**RESOLUTIONS OF STATE OF IDAHO AND
ENVIRONMENTAL PROTECTION AGENCY COMMENTS
PLUS DISCUSSION OF ADDITIONAL CHANGES MADE IN THE WORK PLAN BY DOE**

RE: Review Comments on the Remedial Investigation/Feasibility Study (RI/FS) Work Plan for the Test Area North (TAN) Groundwater Operable Unit (OU 1-07B)

REVIEW COMMENTS DRAFT REMEDIAL INVESTIGATION/FEASIBILITY STUDY WORK PLAN AND ADDENDA FOR THE TEST AREA NORTH GROUNDWATER OPERABLE UNIT AT THE IDAHO NATIONAL ENGINEERING LABORATORY

Figure 2-2. Map of the INEL and surrounding area.

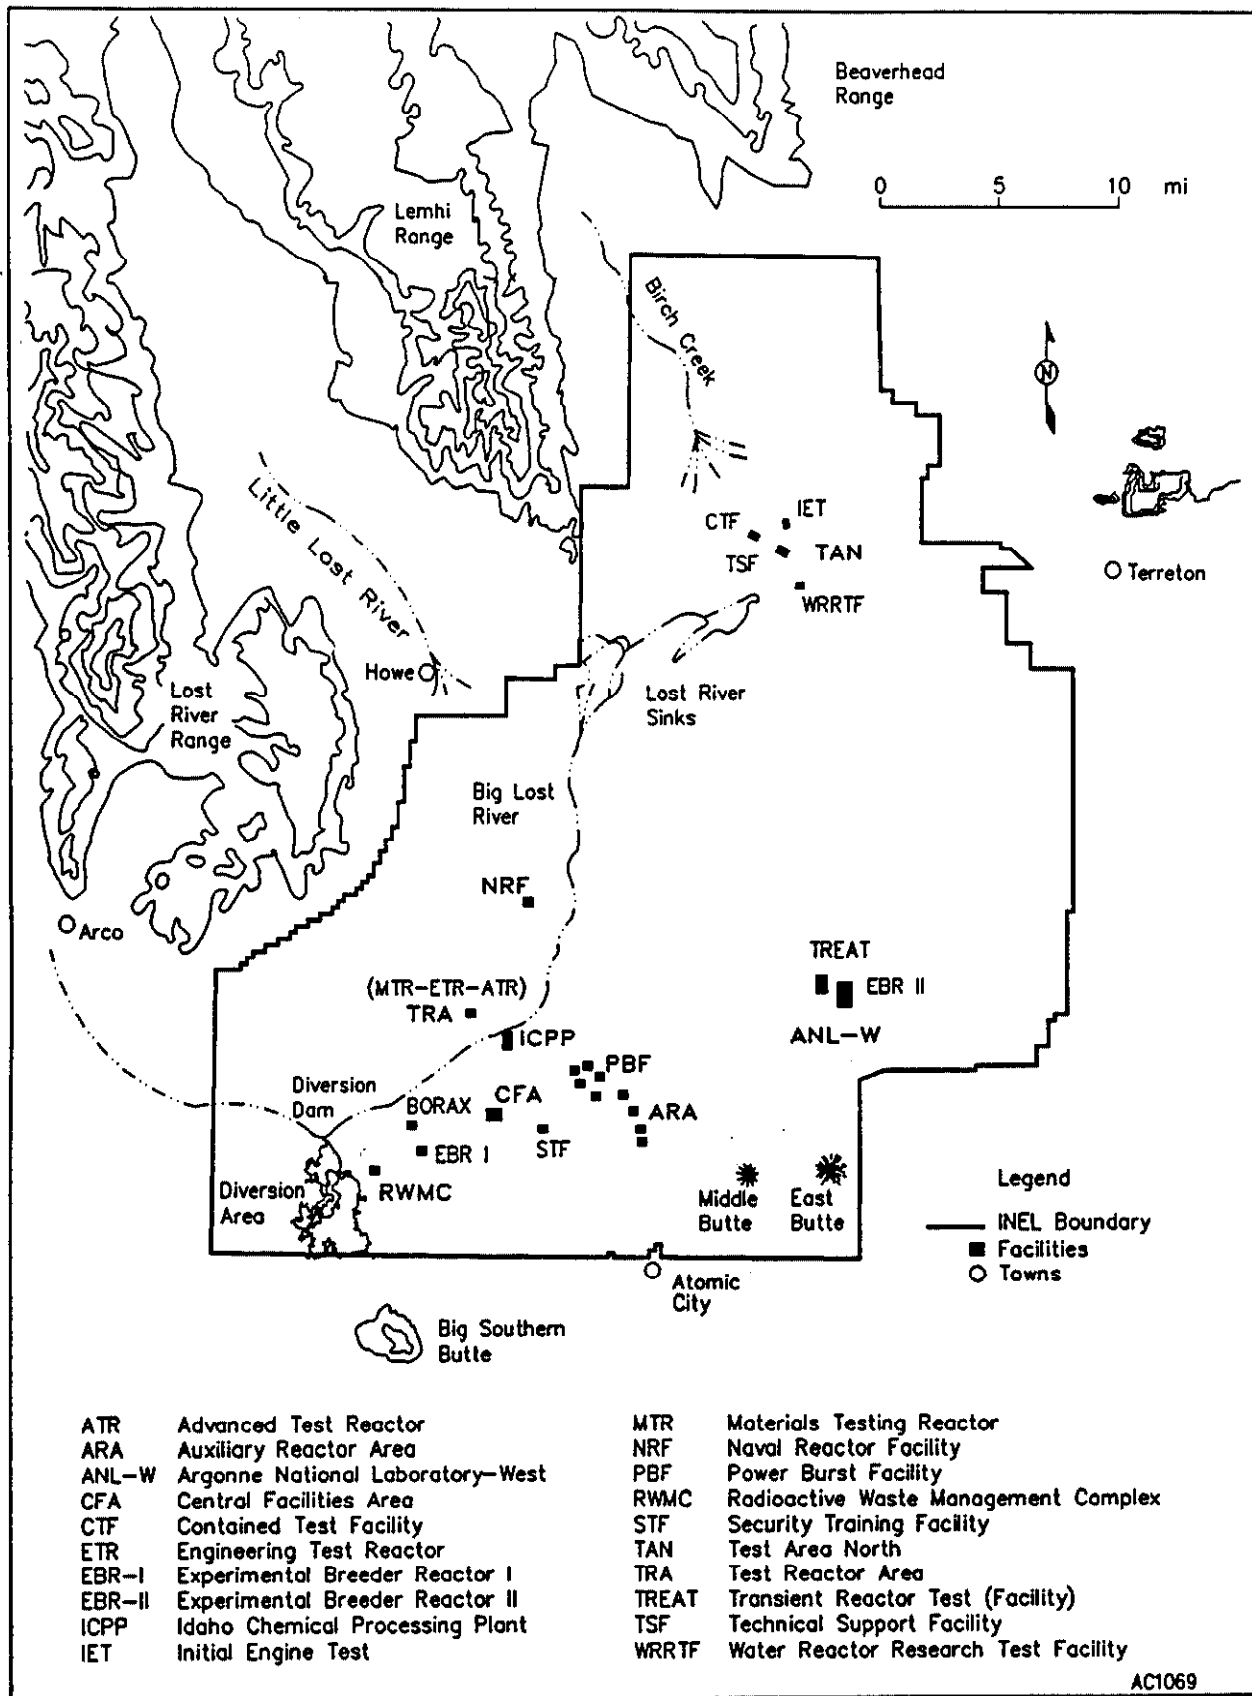
33. Figure 2-2, page 2-11 of the Field Sampling Plan. As stated earlier (page 5-16), an additional well pair location is necessary midway between the TSF Injection Well and the GIN-5 well.

TAN 10 is not properly located compared to Figure 2.2. If the GIN wells head data is considered in drawing the contours, the 4583 contour line would need to swing 3,000 feet to the southeast into the GIN well area before returning to the capture zone around TAN 1.

Resolution: An additional well (TAN-21) has been added along McKinley Boulevard.

Resolution: TAN-10 is properly located on Figure 2-15a (now 2-16a) and 5-2a but was not accurate on Figure 2-2. Figure 2-2 has been updated to be more accurate.

Figure 2-17. Specific conductance concentration at USGS 24.

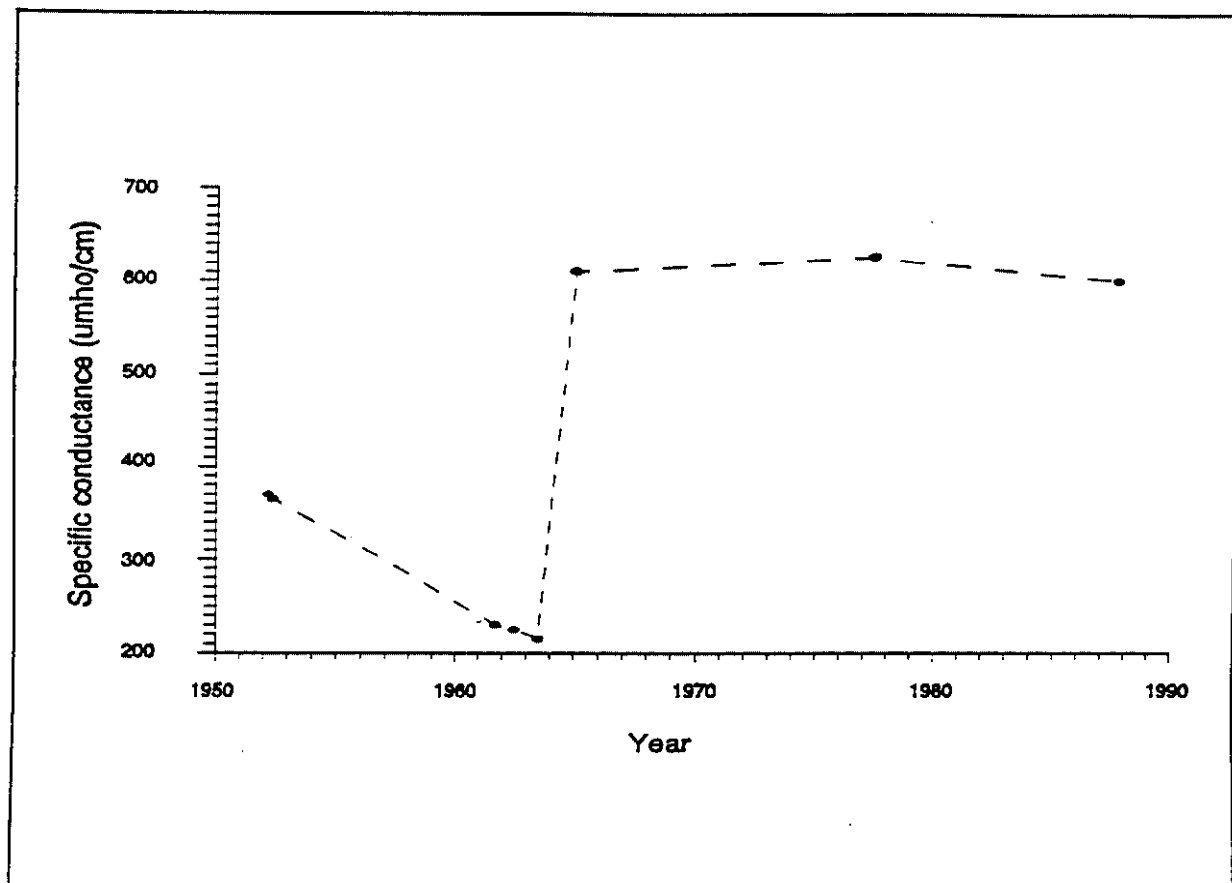
5. Page 2-27, Section 2.1.6.5, Rate of Flow. The average contaminant migration velocity calculated by A. H. Wylie is 0.6 feet per day. This figure is based on, "arrival times at TAN well USGS 24." The figures used are 1,425 ft in 2,190 days. This is a time period of 6 years. The injection well was in operation from 1956 to 1972.

Clarification is needed. Was the contamination detected in USGS-24 before it was detected in the production wells? If so, when, by whom, and what was detected? This statement contradicts the Environmental Impact Analysis, page 3, which discusses a 30 year transport time.

Resolution: The pre-1987 data on USGS-24 was obtained from routine specific conductance tests done by the USGS on their wells at the INEL. We are not aware of any organic data prior to 1987. The discussion has been expanded to clarify the use of this technique for determining rate of flow (see revised Section 2.1.6.5).

Figure 2-22. The Test Area North/Technical Support Facility plot plan.

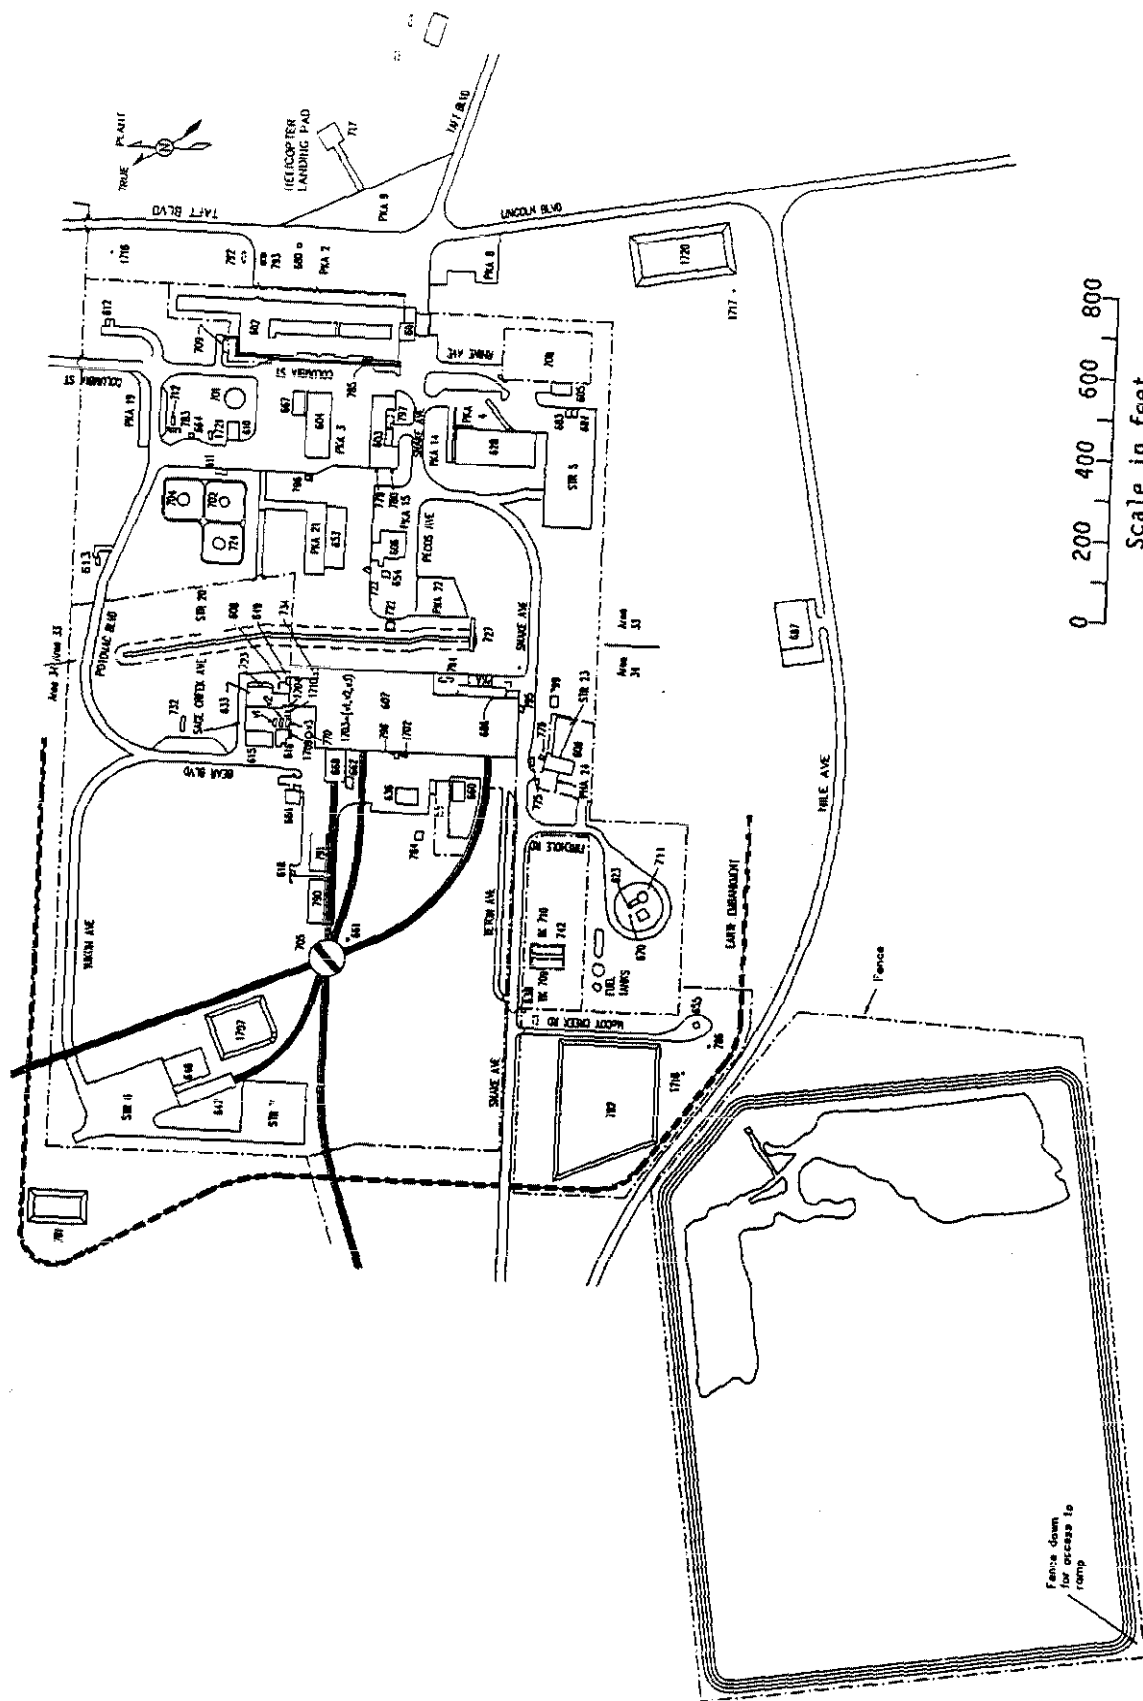
11. Page 2-49, last paragraph. Are the T-710A and T-710B storage tanks also know as the PM2-A storage tanks? Didn't the long term storage tanks depicted in Figure 2-19 fill to capacity within several years of initial start-up of the Intermediate Level Waste Disposal System (TSF-09)?

Resolution: The tanks did fill and were emptied by TAN personnel in the late 50's and early 60's. The waste was reportedly taken to the injection well and dumped according to personnel interviews. Section 2.3.6, p 2-61 has been modified to include a paragraph on this action. Other sections of the Work Plan that discuss uses of the injection well have also been modified to include the disposal of evaporator sludges.
